CONSTRUCTION PLANS FOR

NOR ESTE MANOR SUBDIVISION

DRAINAGE, GRADING, PAVING AND UTILITY
IMPROVEMENTS

NOTE:
SHEETS AFFECTED BY CHANGE ORDER #1
AS INDICATED

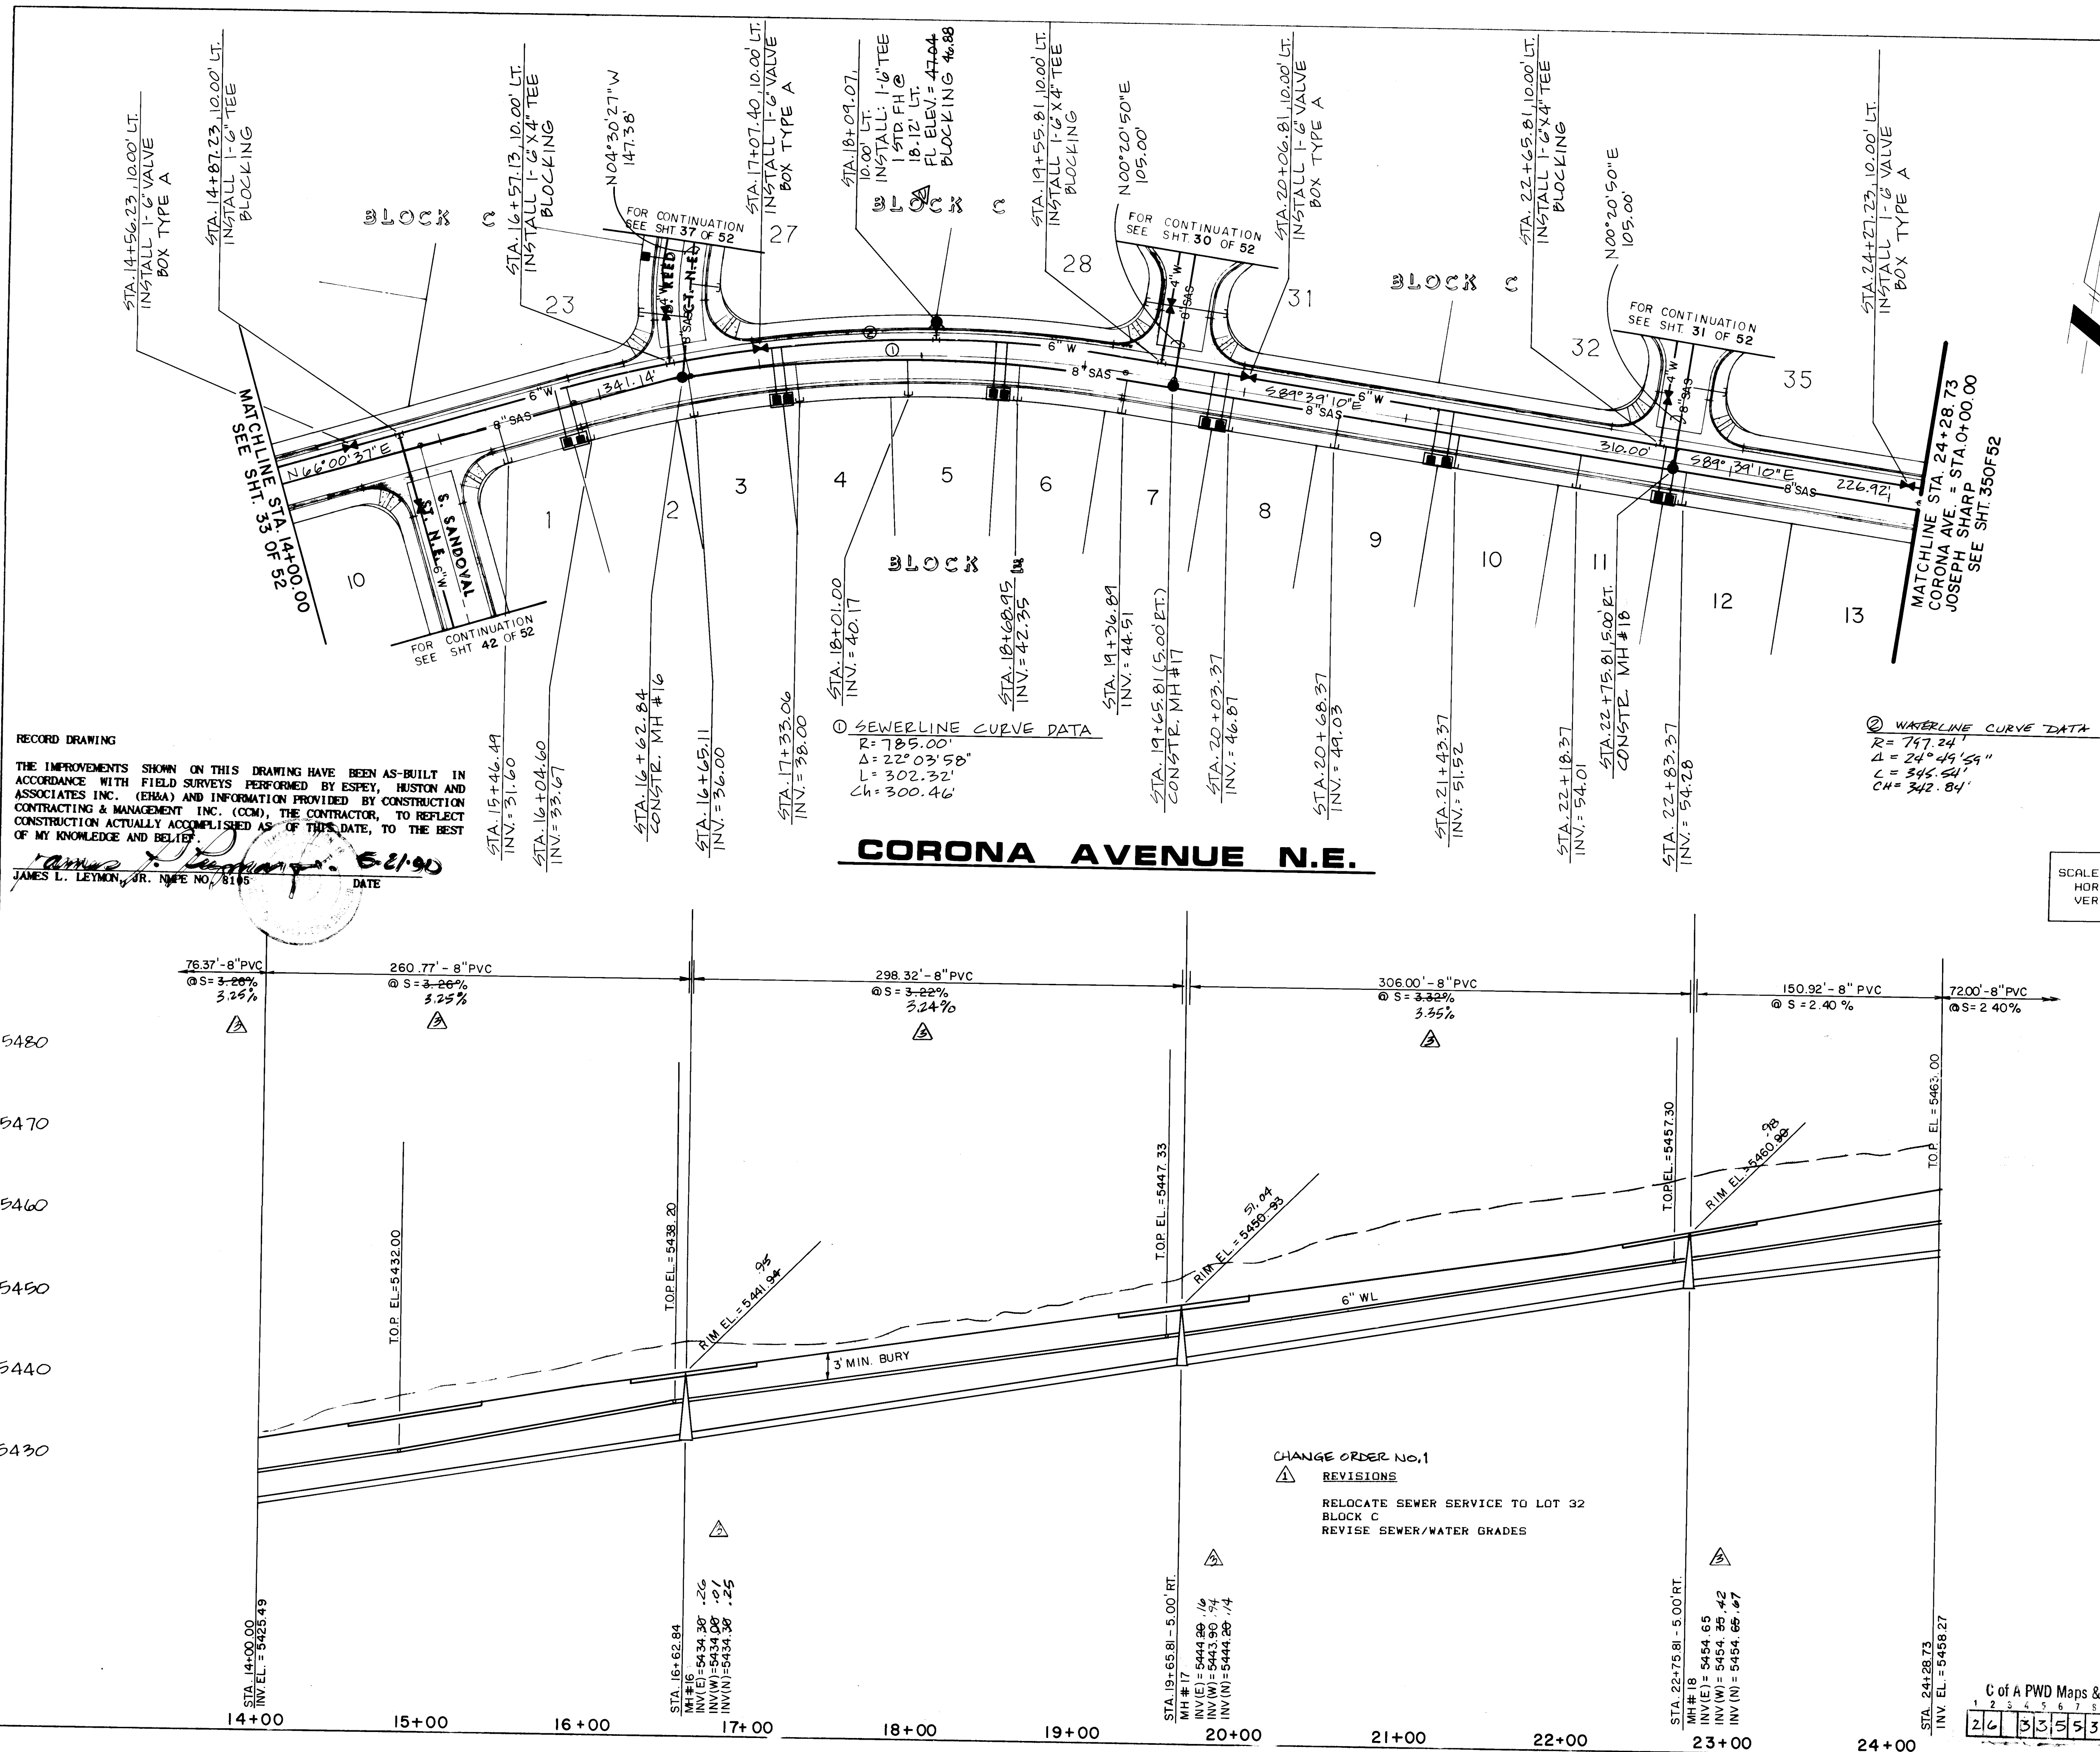
CHANGE ORDER NO.1
⚠ REVISIONS
RELOCATE SEWER SERVICE TO LOT 32
BLOCK C
REVISE SEWER/WATER GRADES

NOR ESTE MANOR
JOSEPH SHARP ST. N.E. STA. 0+00.00 TO STA. 8+89.38
UTILITY PLAN AND PROFILE

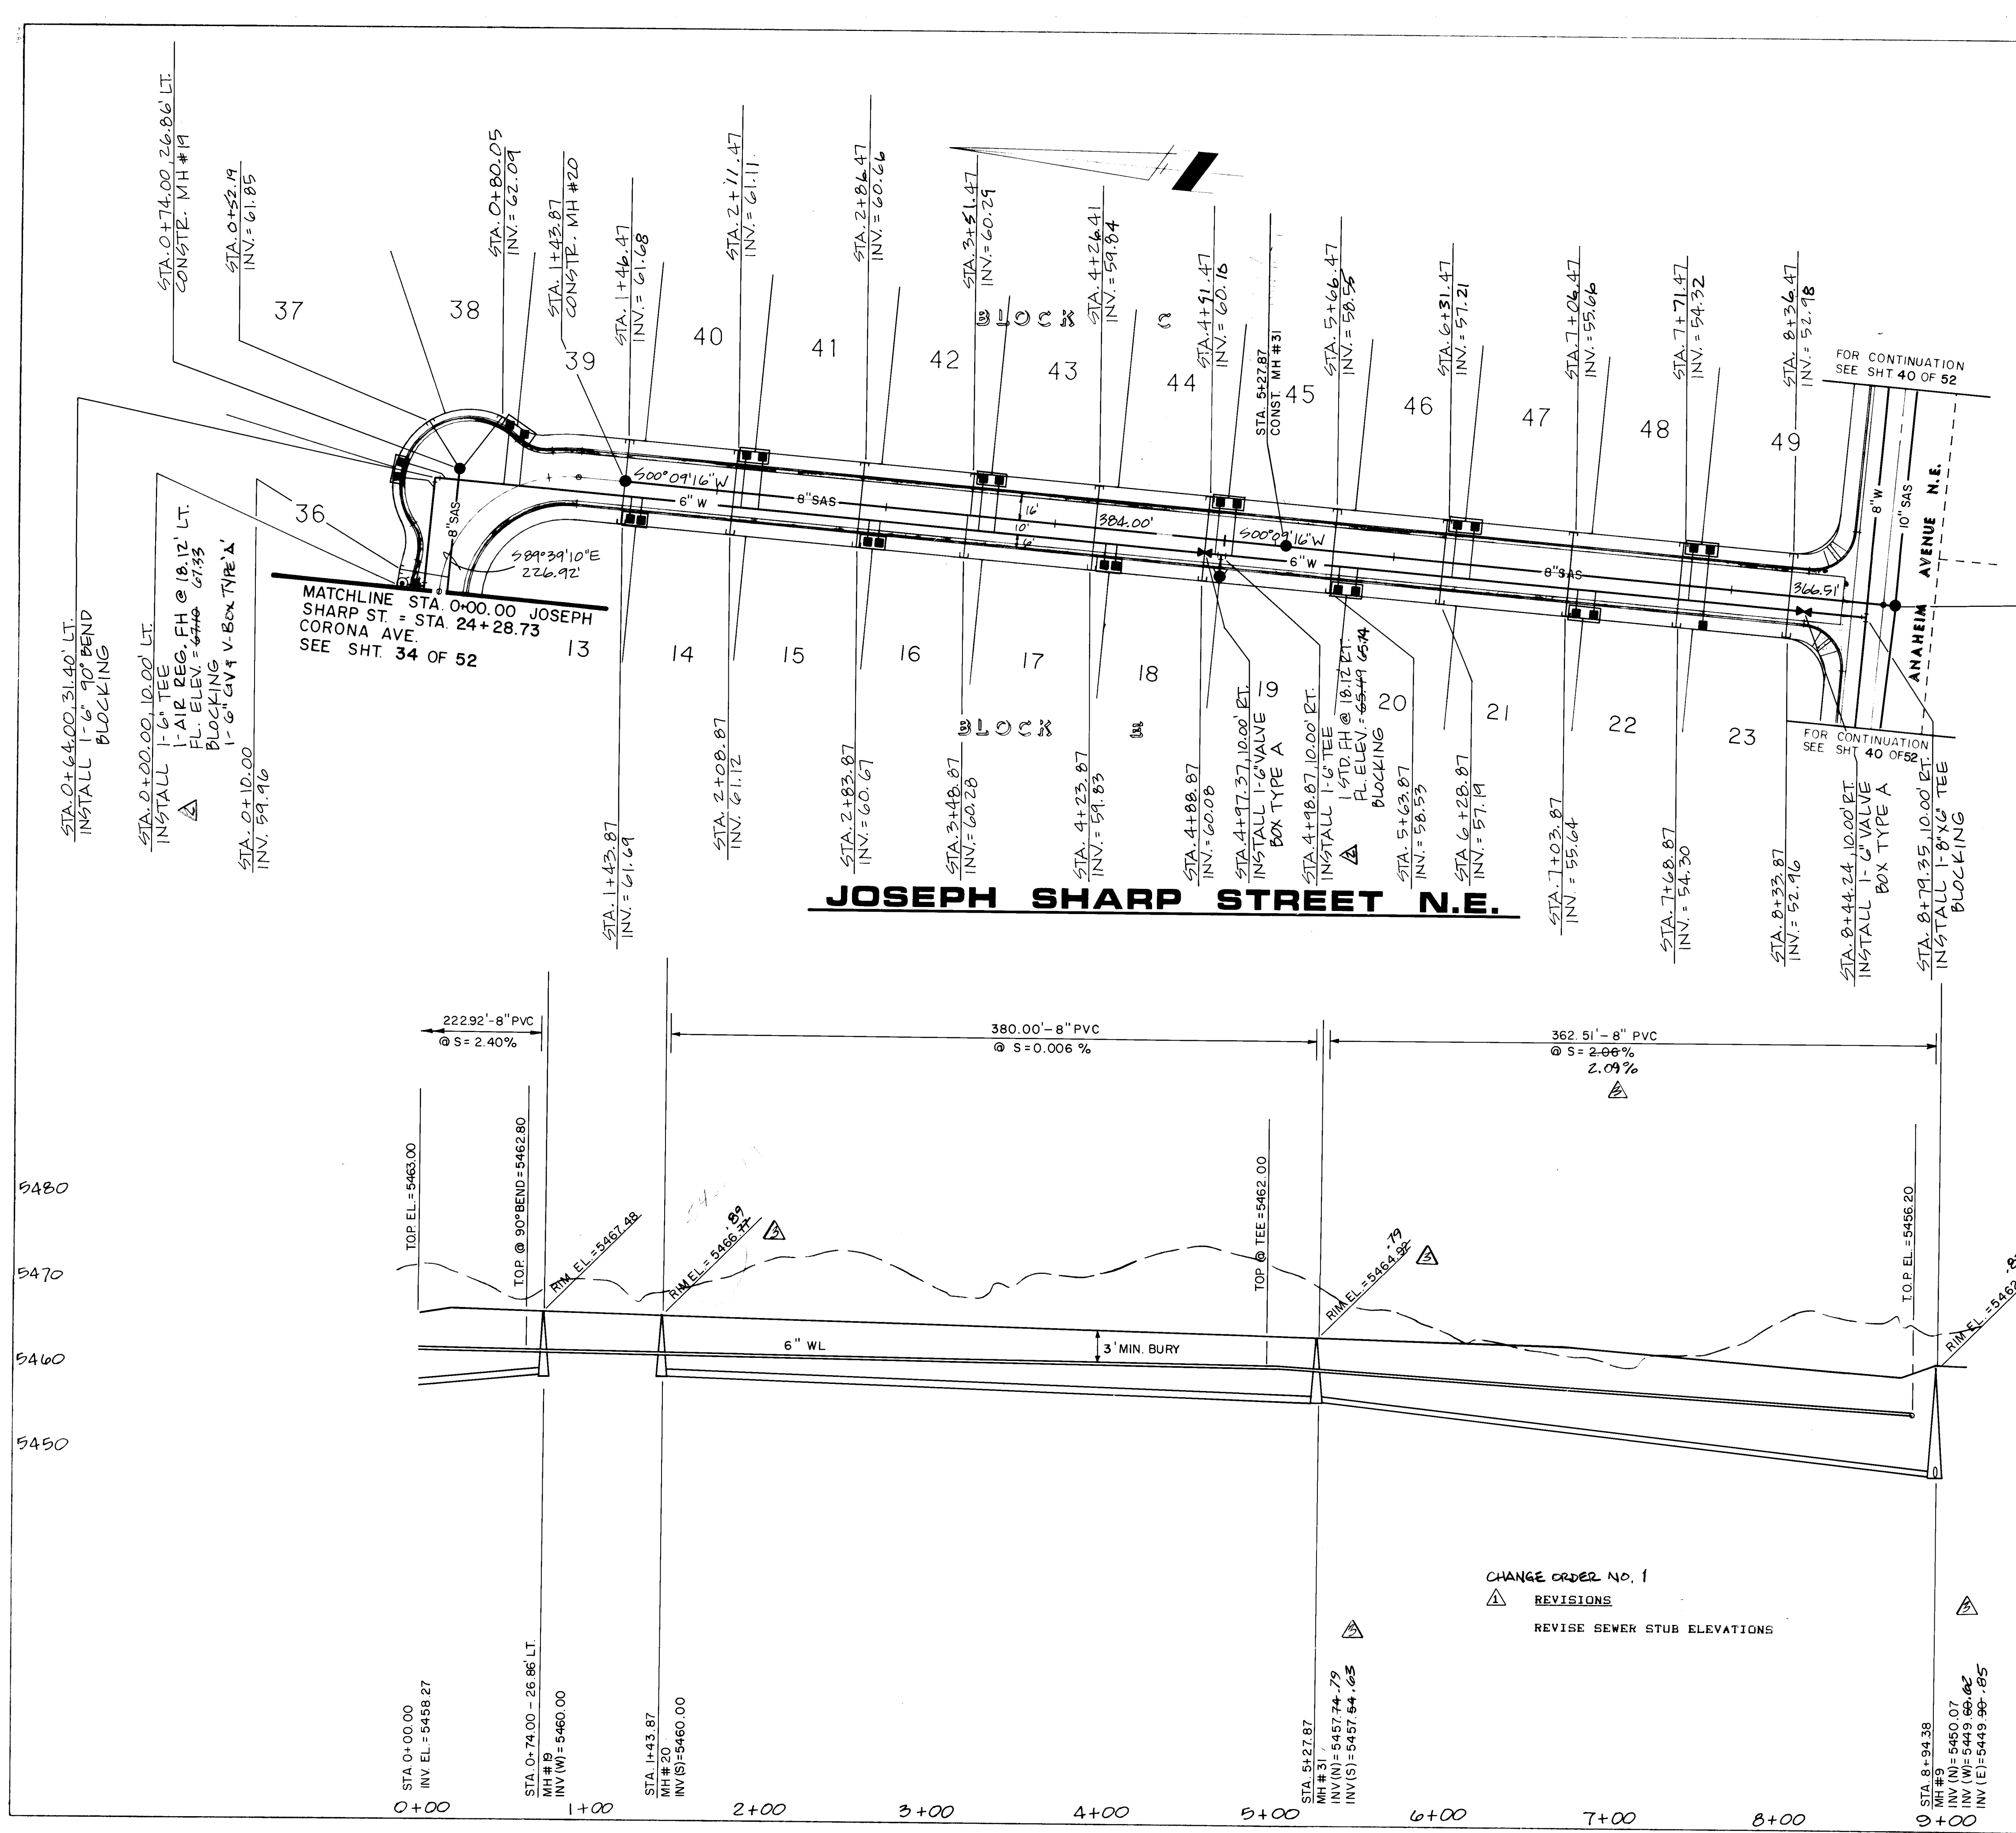
CHANGE ORDER NO. 1

REVISE SEWER STUB ELEVATIONS
